TRAILS AT ASPEN RIDGE - FILING NO. 4

PUBLIC WATERLINE PLANS

DECEMBER 2021

DESIGNED BY: JSE SCALE: HORIZ 1" = 40' DATE ISSUED: DECEMBER 2021 DRAWING No. WT03
DRAWN BY: JSE HORIZ 1" = 40' SHEET 5 OF 12
CHECKED BY: NMS VERT 1" = 5'

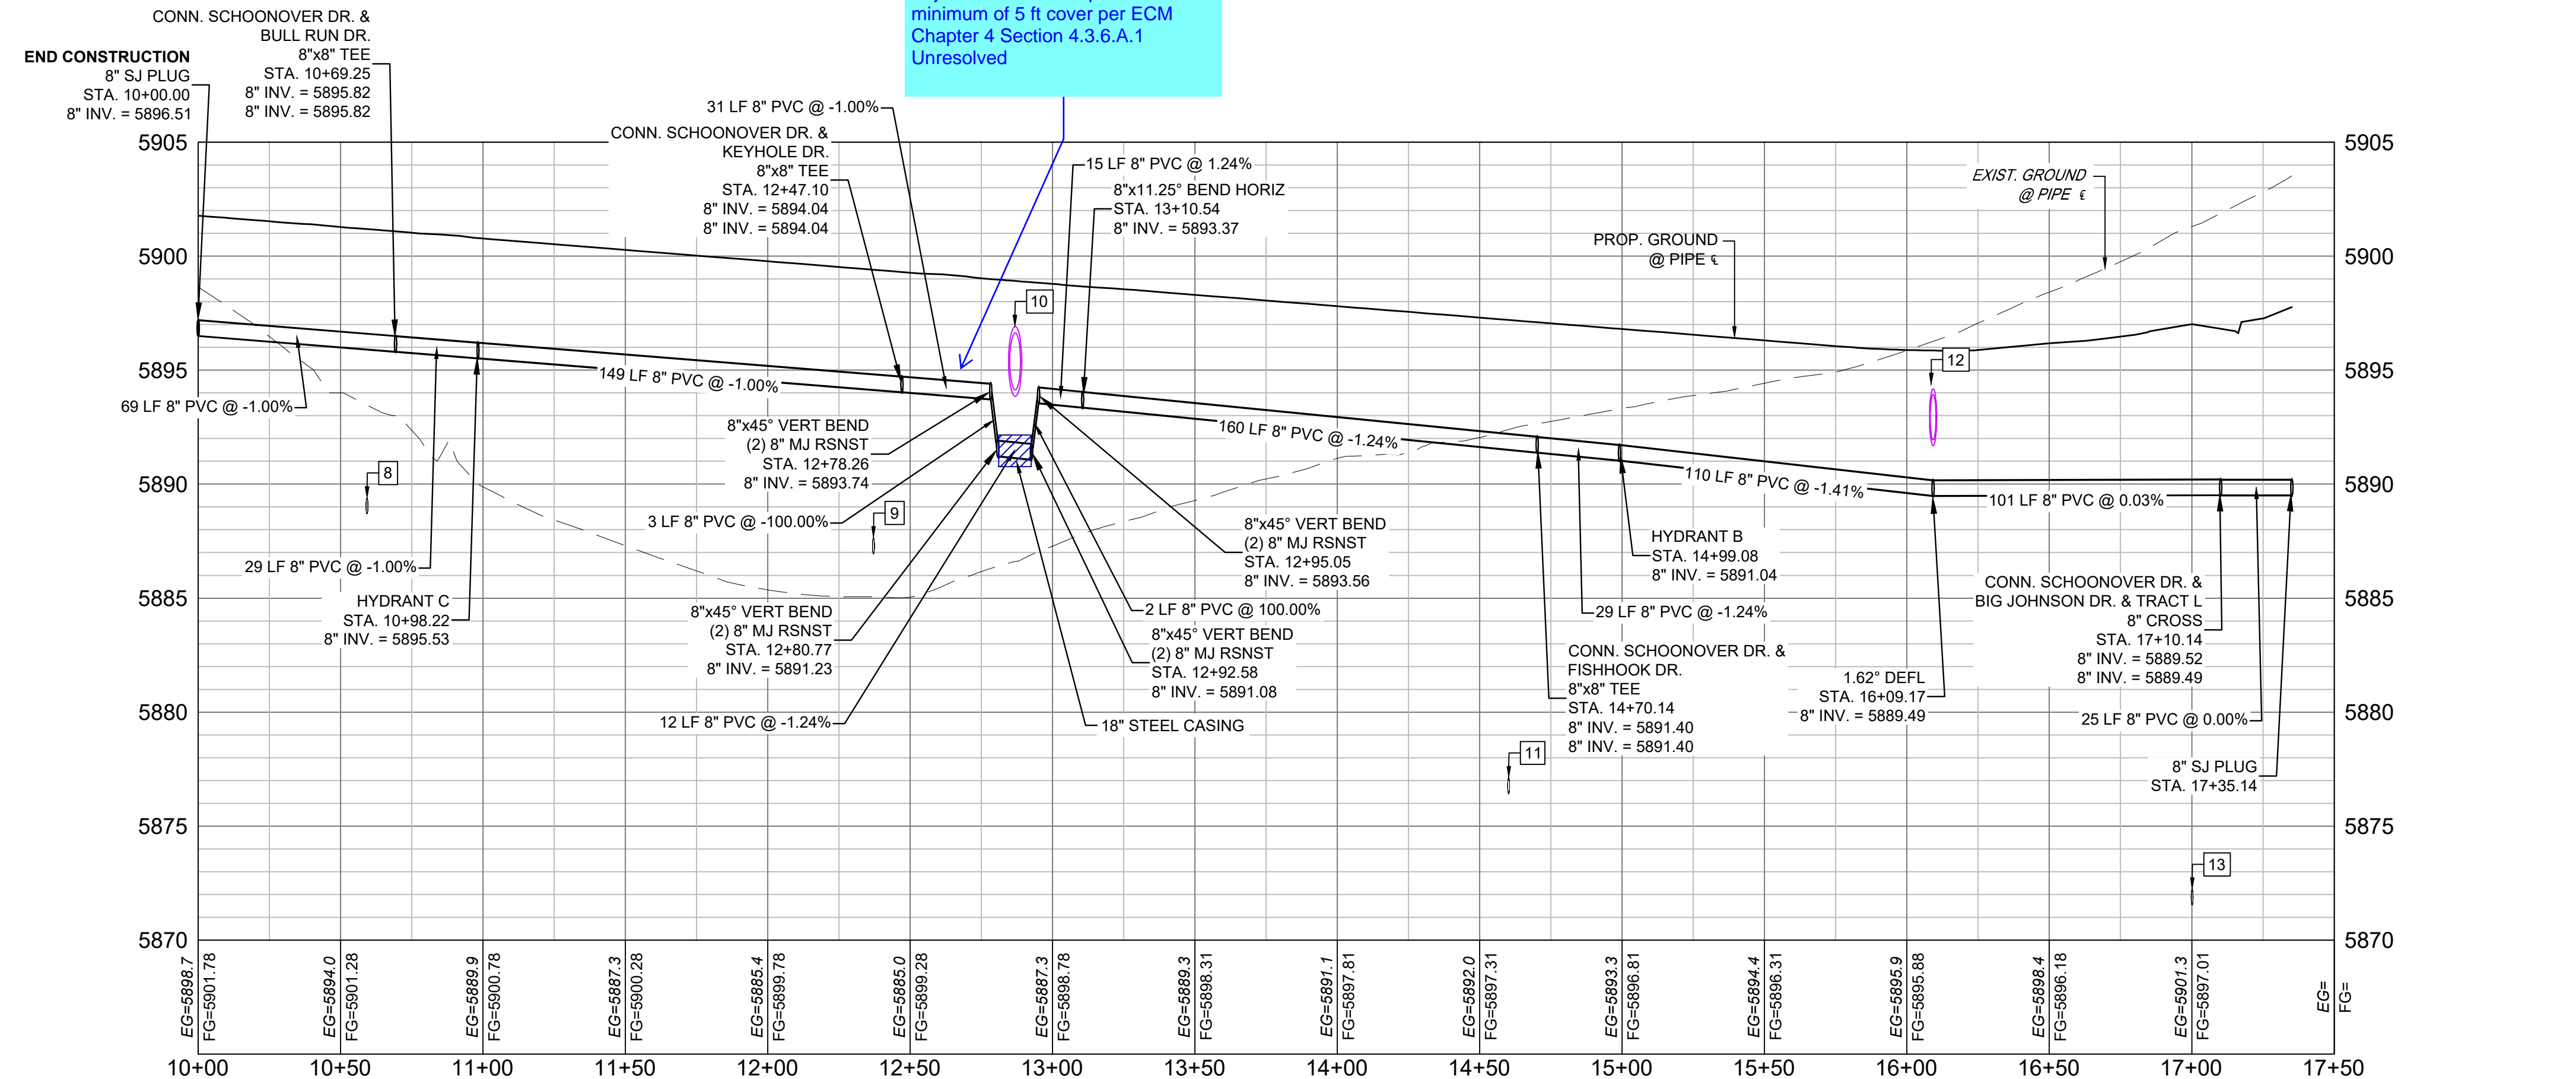
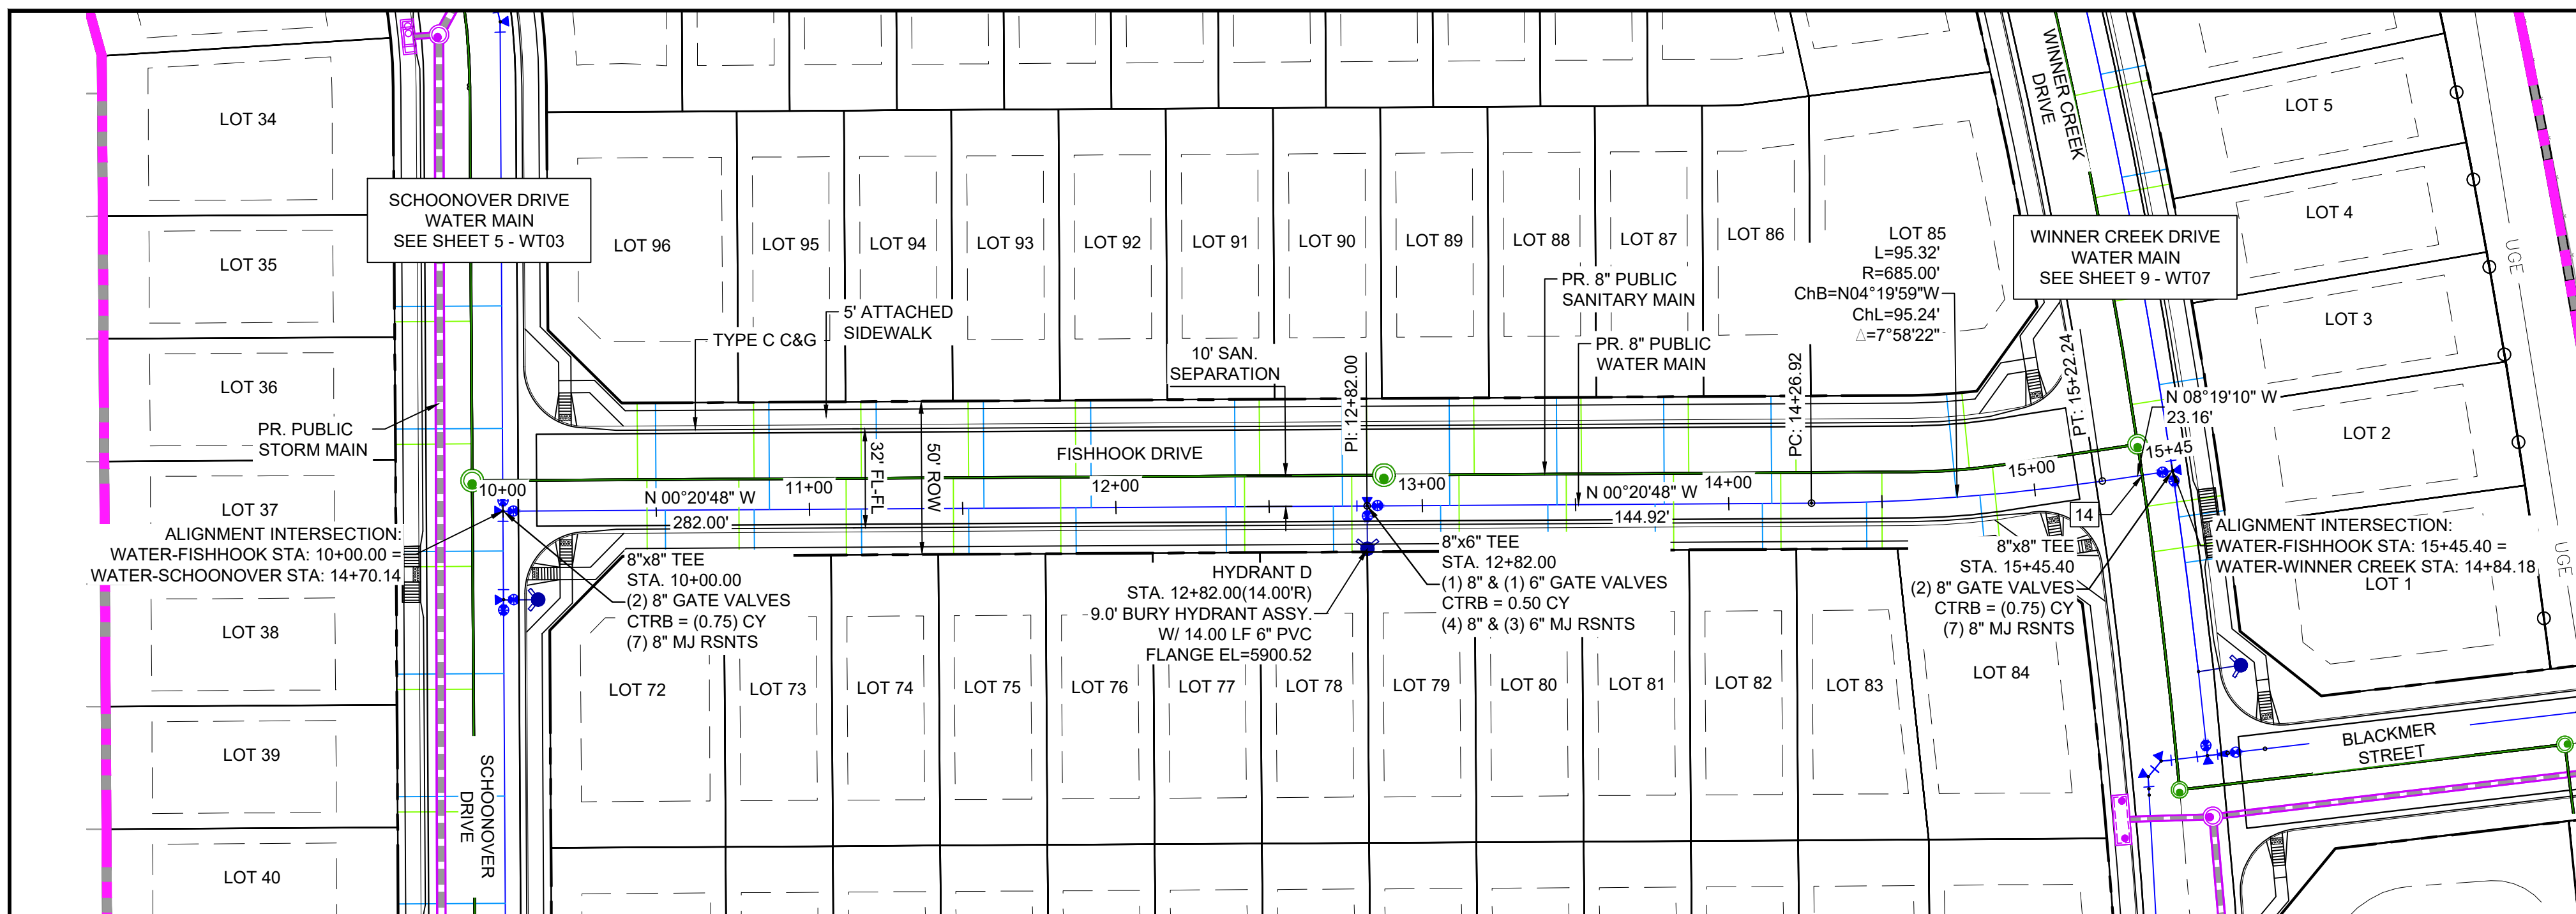
Adjust water main to provide a minimum of 5 ft cover per ECM Chapter 4 Section 4.3.6.A.1 Unresolved

Verify storm bottom of pipe elevation. Per profile, bottom of pipe elev appears higher than this elev

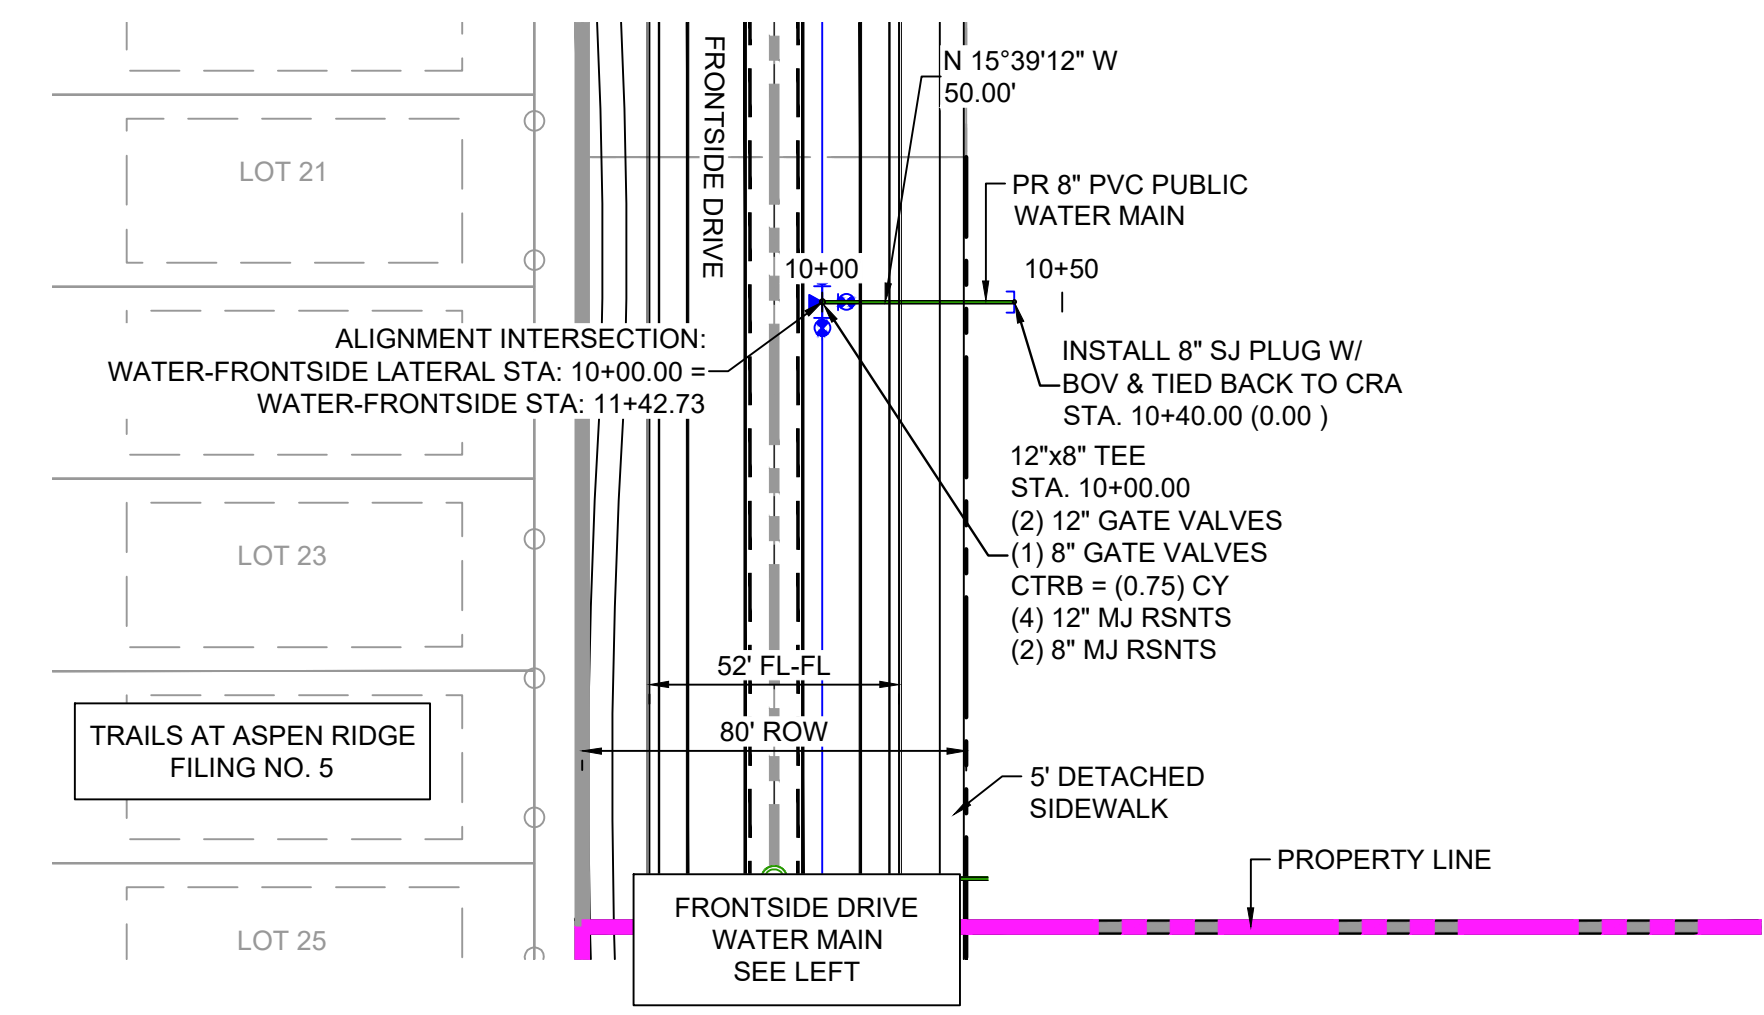
Add PCD File No SF-21-024
